Stanford House, 9 Nestles Avenue, Hayes UB3 – Daylight, Sunlight & Overshadowing

In addition we have been provided with a letter of 9th November 2020 prepared by Lambert Smith Hampton following a review of our detailed report of July 2020. The Lambert Smith Hampton letter raised some queries in respect of our report. We have provided further clarification in respect of these elements below and additional technical information is attached where useful to aid in addressing these queries.

Revised western elevation indicating area of proposed changes.

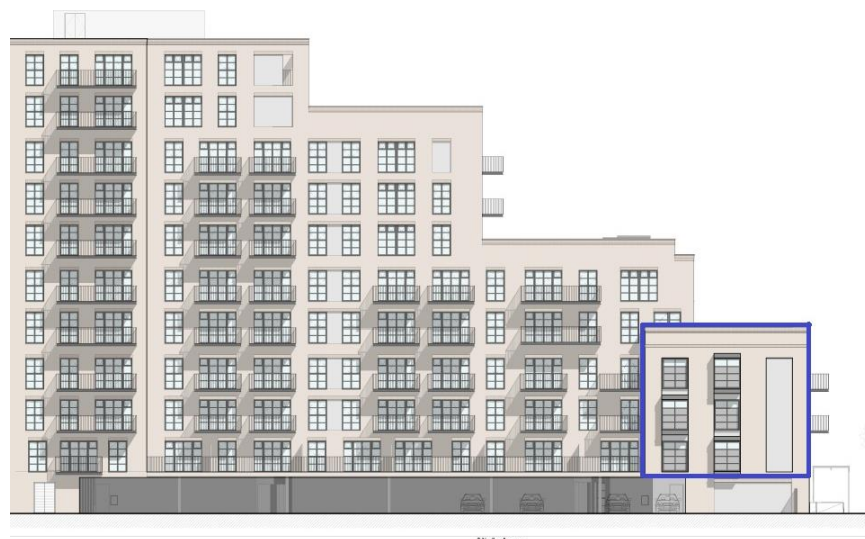
These changes include the redesign and removal of some windows to the southwestern flank elevation where it is closest to the neighbouring site at 7 Nestles Avenue. Glazed elements have been removed additional return windows and a staggered 'bay' element added to retain good daylight levels to these units. The areas of these changes are highlighted below:

The results of our internal daylight assessment show that the rooms affected by the revisions to their glazing continue to meet the ADF targets for their specific room use. These rooms are identified as First Floor R31 & R32, Second Floor R29 & R30 and Third Floor R29 & R30.

Title Block D
Window Map

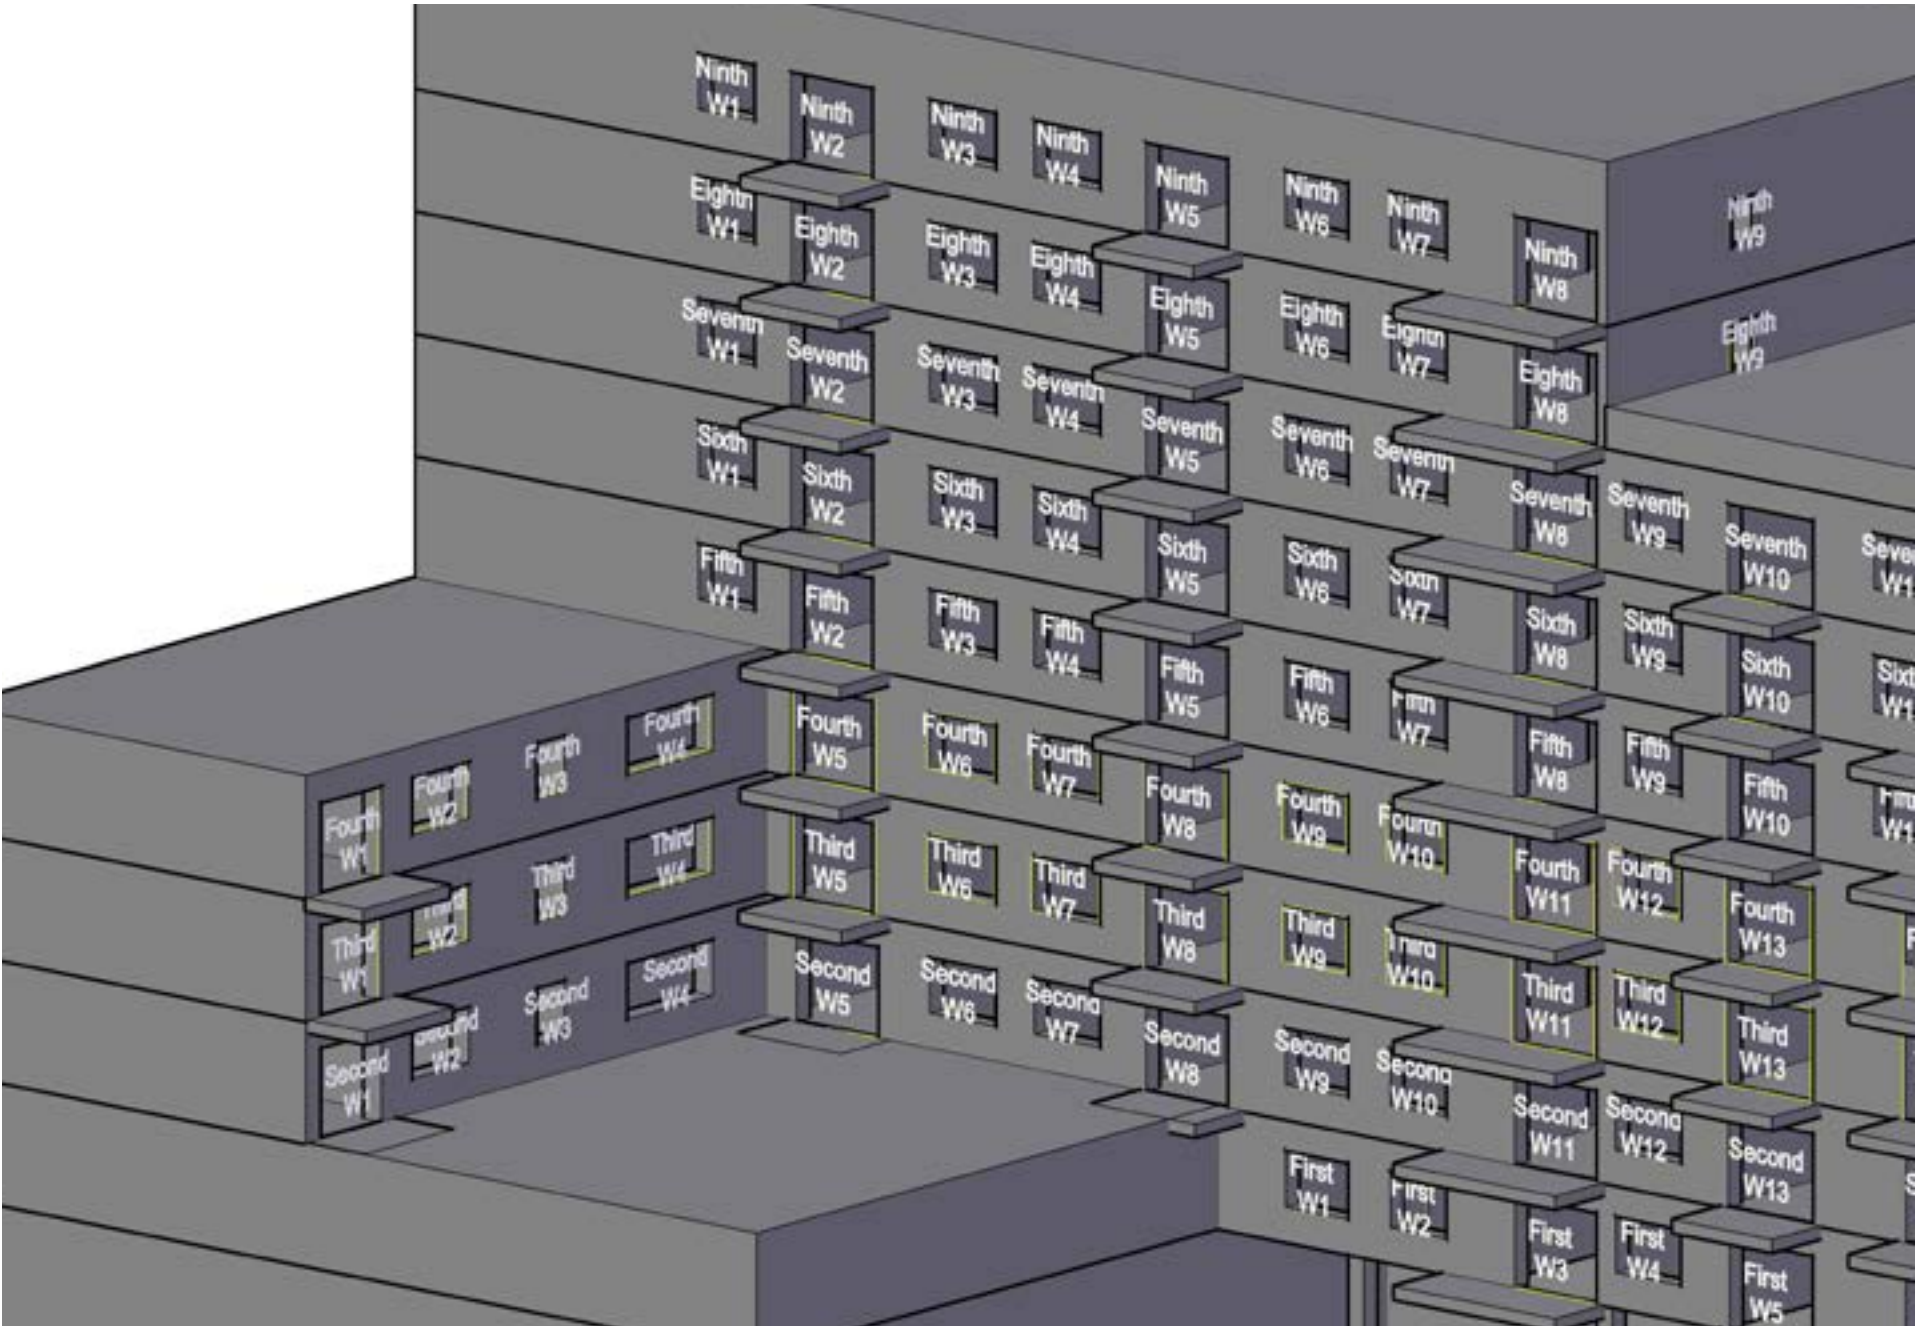
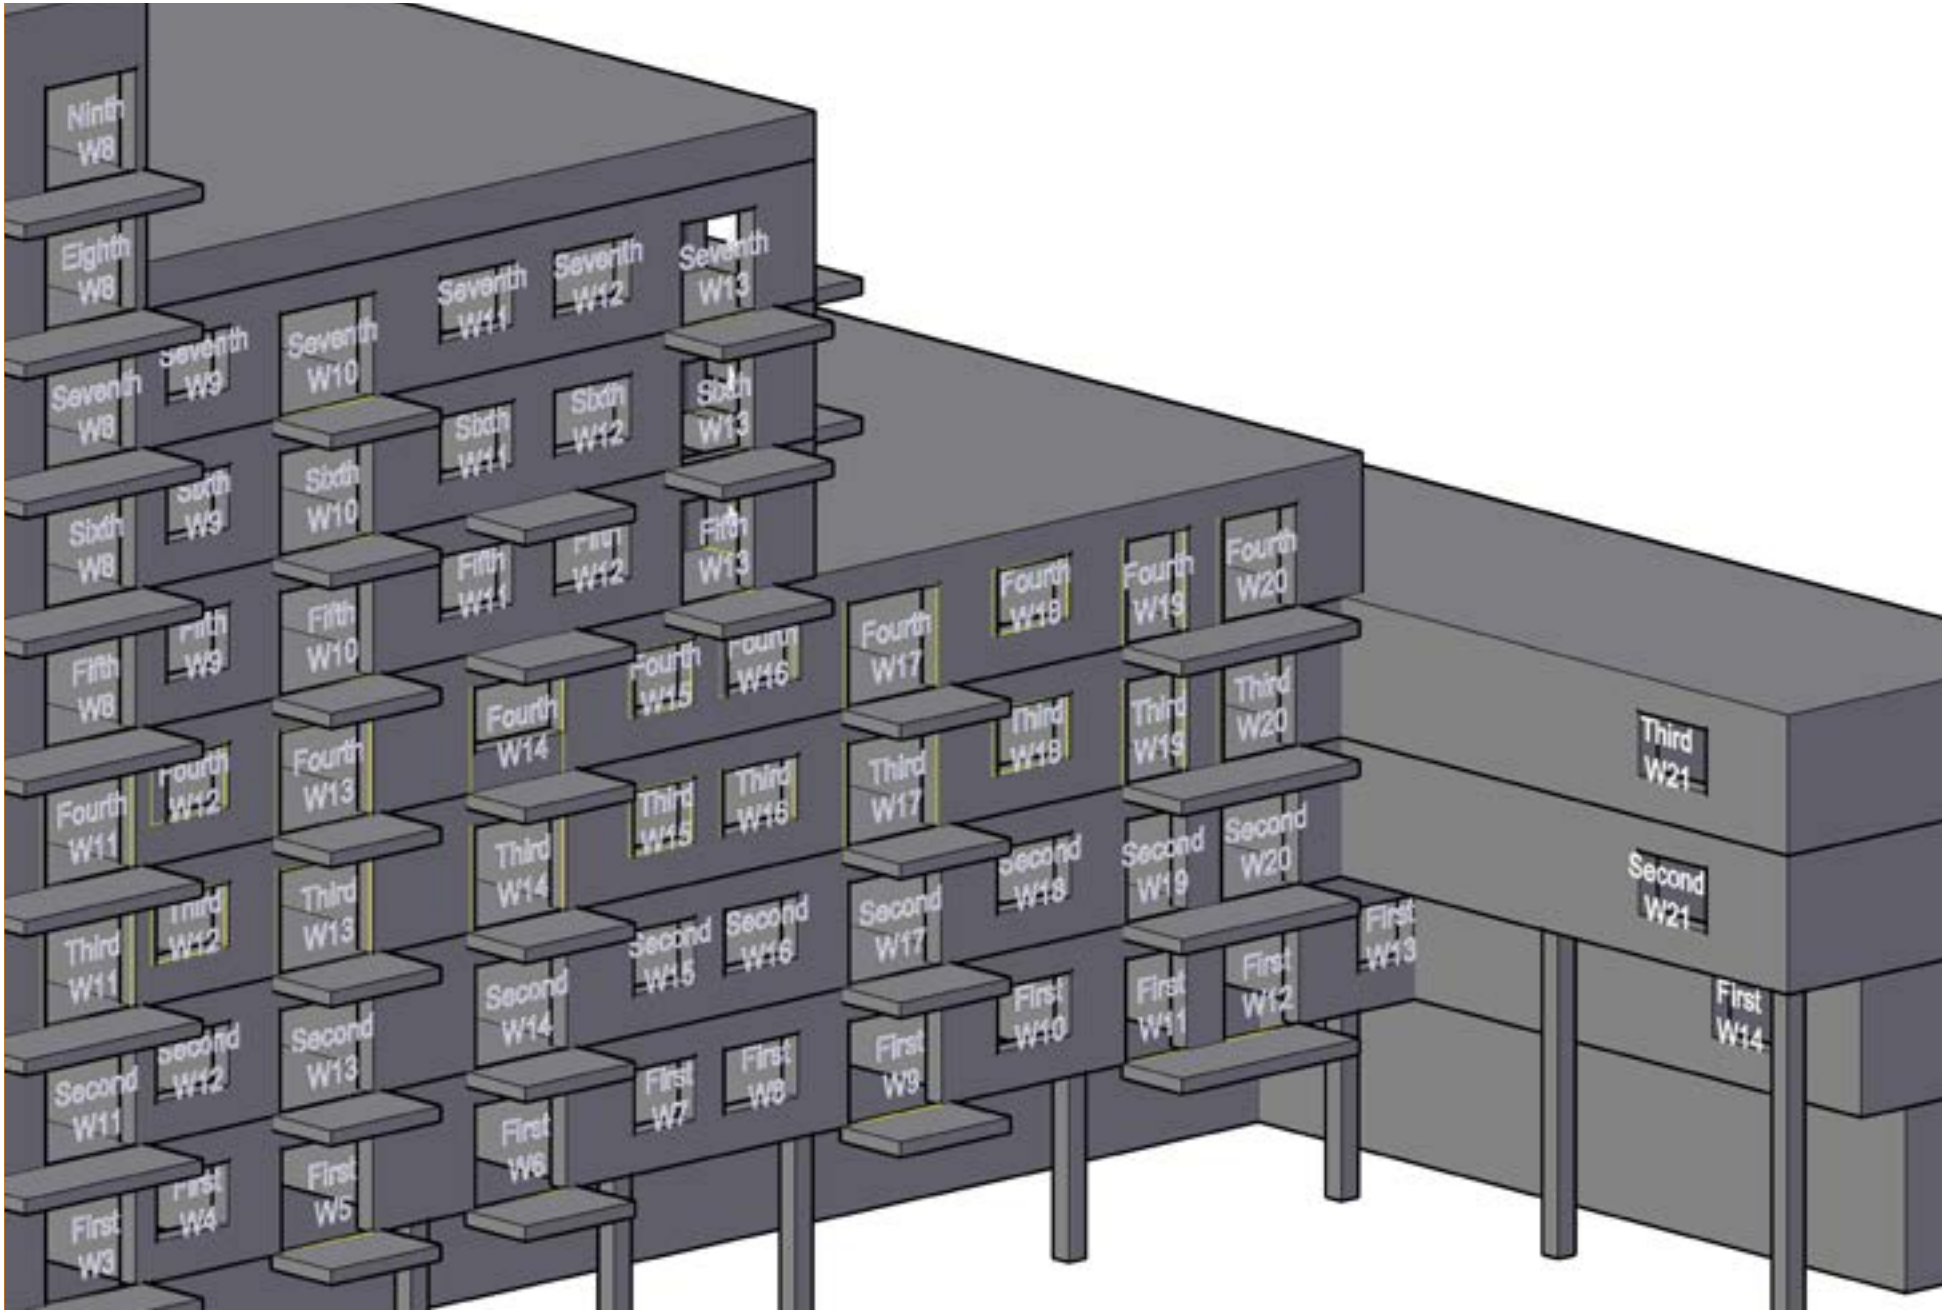
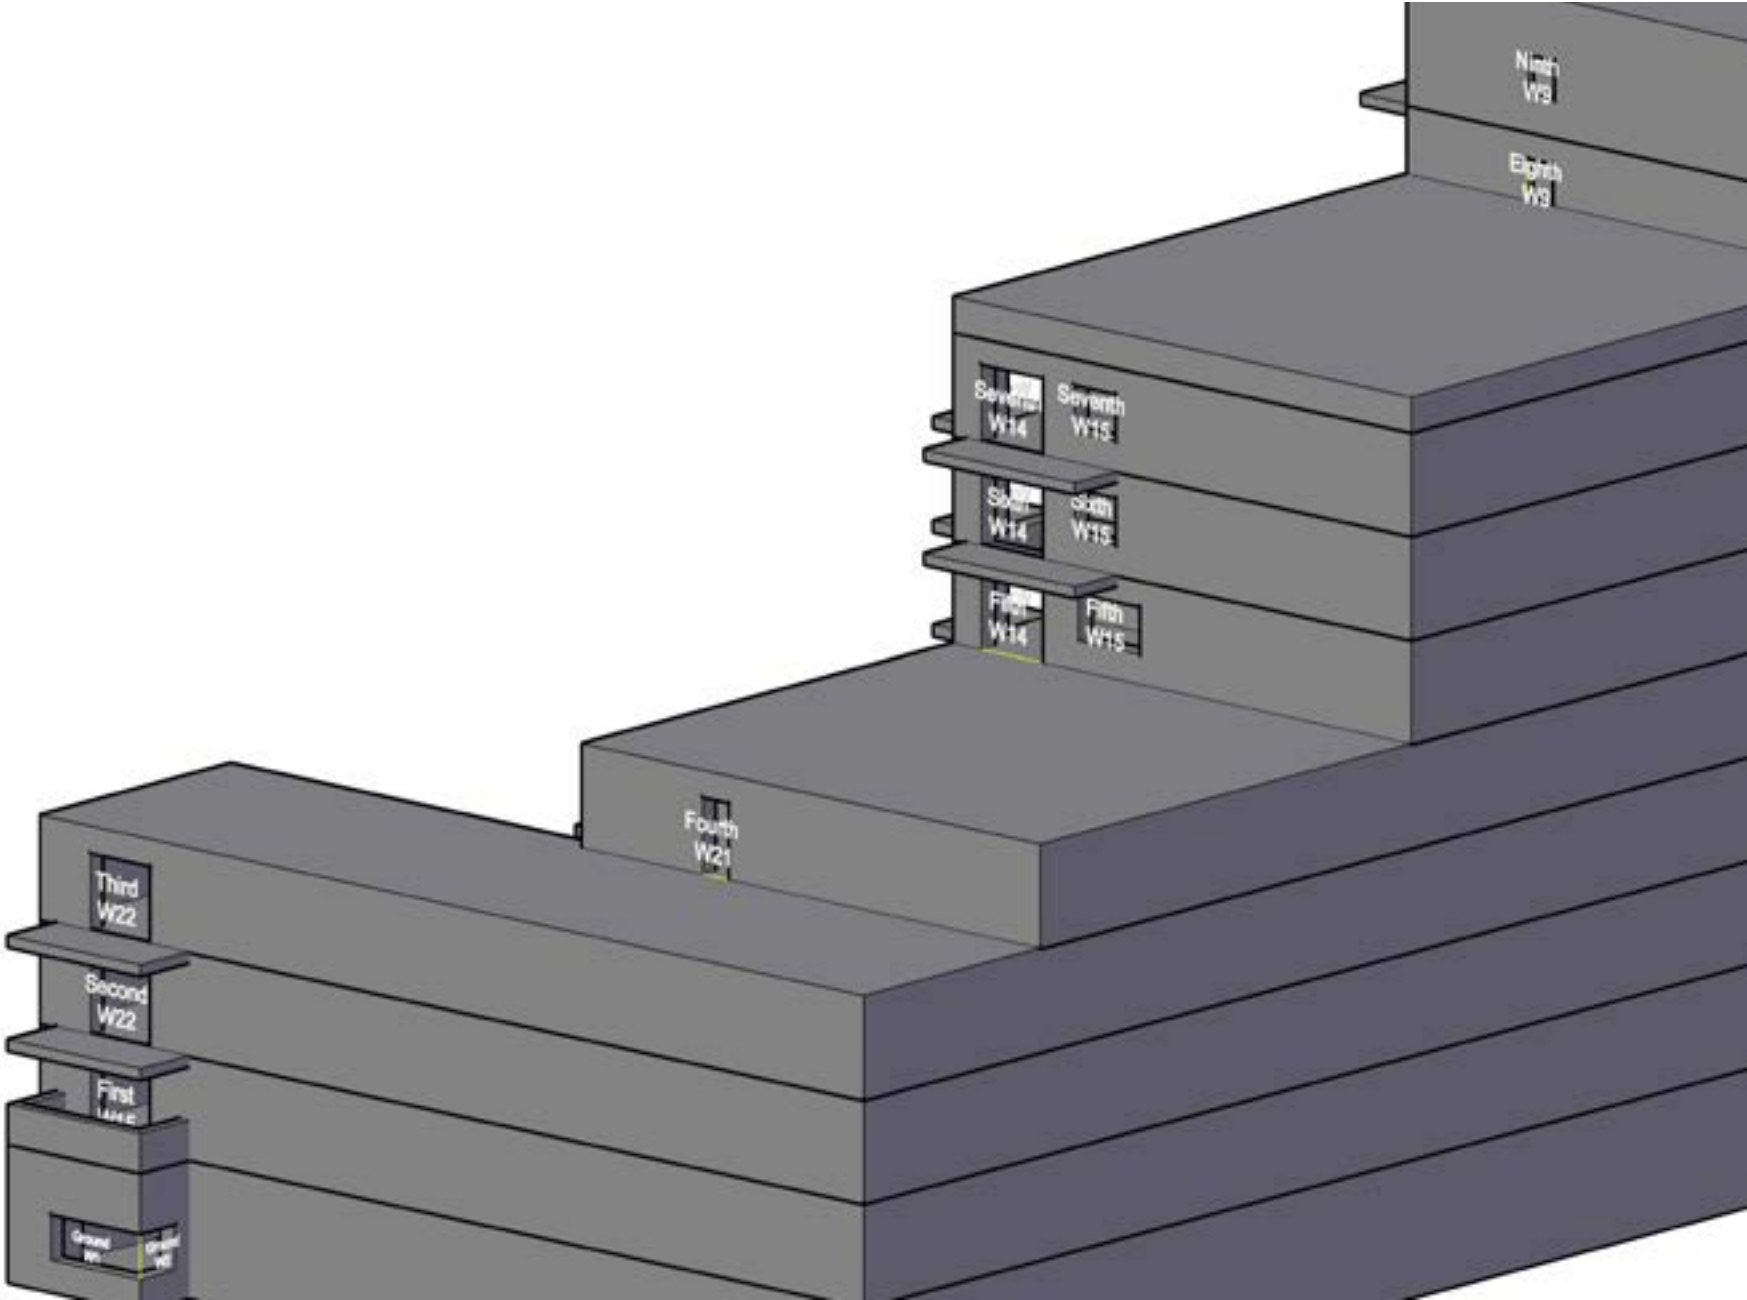
In terms of the potential effects of the proposal upon neighbouring properties, the review undertaken by Lambert Smith Hampton noted the absence of 'balconies in place' results assessing the retained daylight levels to block D of the former Nestle Factory site situated to the east of the scheme along Nestles Avenue.

A full set of results showing the impacts of the proposed scheme on Block D with balconies in place is attached at appendix 1 and also includes a full set of window maps showing the location of each window assessed that can be cross referenced to our study.

As per our July 2020 report our results show that 108 of the 132 rooms assessed within block D continue to meet the ADF targets with the proposal in place. This is achieved even though there are limiting factors in respect of both the provision of balconies to this block and some very deep spaces of almost 7m.

Of the 22 LKD's within Block D which fall below the 1.5% ADF target with the balconies in place we would note that 12 are within 0.2-0.3% and therefore represent only marginal deviations. The benefit of the balconies to the occupiers of the units is noted by Mr Blackman in the Lambert Smith Hampton review as often being the cause of light loss and a common trade off with the provision of private amenity space. This is also specifically noted in the Draft Good Quality Homes for All Londoners Guidance (October 2020) which suggests at C5.3 that the *'Mayor encourages boroughs to allow the daylight level on the balcony to contribute to the ADF of the adjacent living space'*. With the effect of balconies taken into account all but 2 of the habitable rooms in Block D (a bedroom and an LKD) will meet their respective ADF target.

Overall the 'with balconies' results continue to show good compliance with appropriate internal daylight targets with deviations generally being limited to rooms with inherent constraints due to room depth and / or balcony provision. Such constraints are common in modern developments and both the BRE guidance and wider policy suggests flexibility should be applied in such scenarios. As such our conclusion remains that the effects upon block D of the former Nestles factory development are wholly acceptable.
